Memorandum

DATE: June 22, 2021

SUBJECT: Office of Planning Report for Large Tract Review Case No. 2020-03
100 V Street, SW (Square 609, Lot 804 and Square 611, Lots 19 and 810)

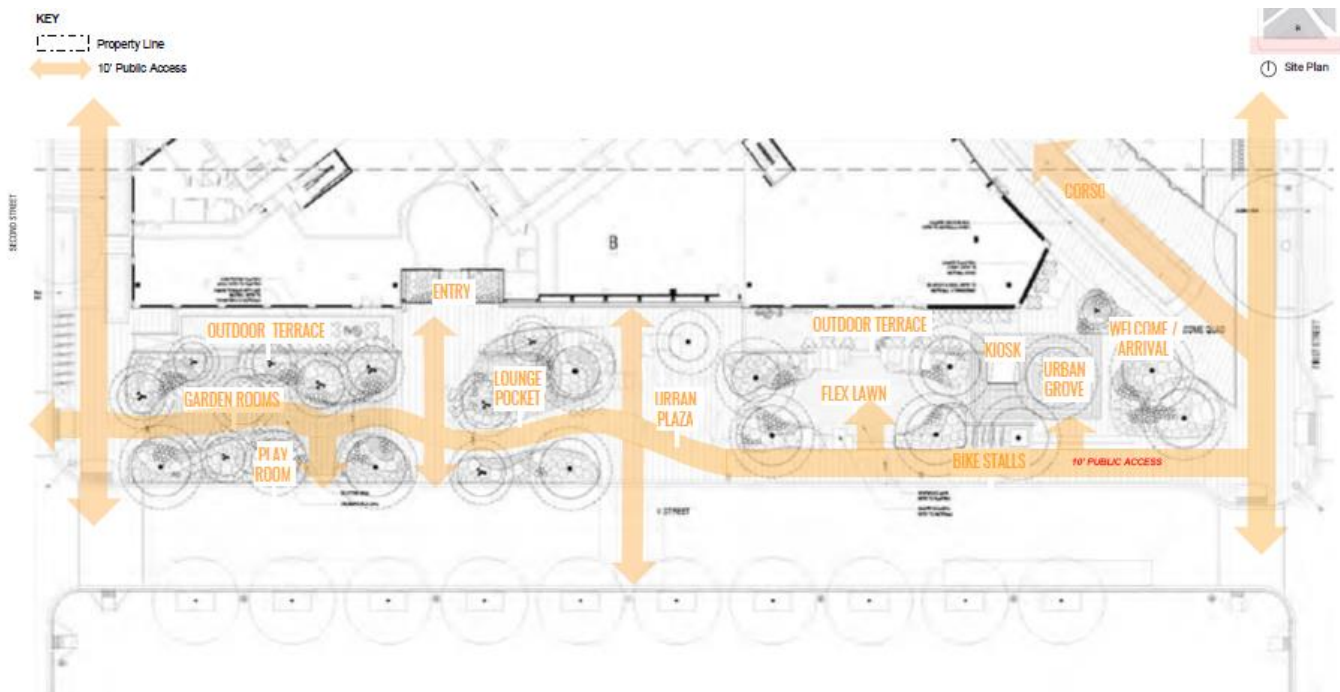
- ANC 6D is requesting that the Applicant reimagine this area (*V Street Park*) and instead of the cacophony of uses currently planned, allow this space to remain as green space in order to reclaim some calm open space for residents and visitors;
- ANC 6D is recommending that the Applicant for this, the largest development in Buzzard Point, aim for a high of perhaps 20% affordable housing;

- Simplify the V Street Park to incorporate more green space and less programmed space;
 - Provide additional resilience measures;
 - Aim for additional affordable housing, up to 20%;
